Providence City Plan Commission

April 16, 2024

AGENDA ITEM 4 ■ 220 BLACKSTONE STREET

OVERVIEW

Site plan with landscaping

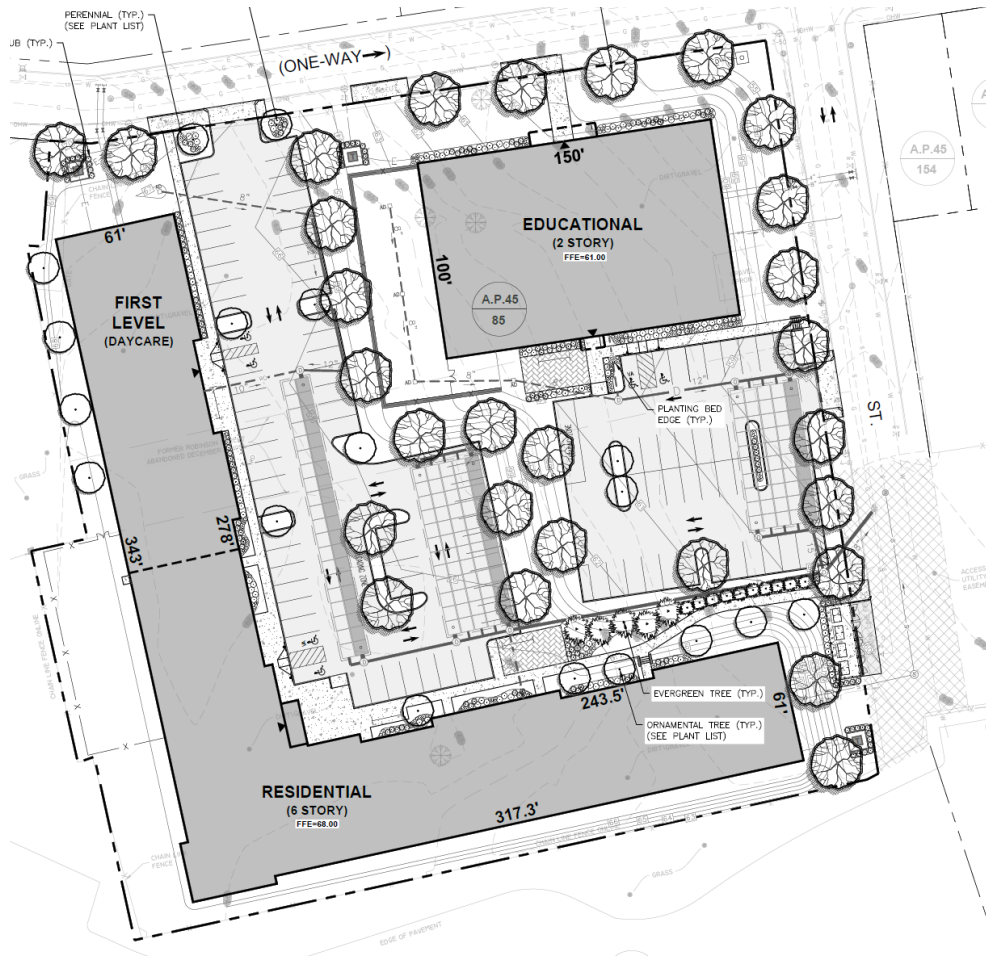
With the parcel measuring approximately 151,389 SF, approximately 22,700 SF (15%) of canopy coverage is required. The applicant will meet this requirement by making plantings of small, medium and large trees around the site, mostly in planting strips around the perimeter of the lot and within the landscaped area between both buildings. In addition, 10% of canopy coverage will be provided for the parking areas, which exceed 20,000 SF. It appears that the plan will provide the required amount of coverage.

The City Forester has identified a significant tree on the site that will be affected by the building's siting. As the tree appears to be in declining health, the Forester is amenable to its removal provided an equivalent amount of canopy coverage is provided. The Forester estimates that 2,300 SF of canopy coverage is required to replace the loss of the tree. The applicant intends to protect a 32" diameter oak tree significant tree located towards the front of the property. The Forester recommends that a tree protection zone with a 30' be implemented and shown on the final plan. The final landscaping plan shall reflect these conditions and shall be subject to the Forester's approval.

1. The drainage calculations and erosion control plan shall be subject to the City Engineer's review.
2. The landscaping plan shall be revised to the Forester's specifications and shall be subject to their approval.
3. The applicant shall apply for an administrative subdivision to orient the lots as depicted on the plan.
4. Final plan approval should be delegated to DPD staff.
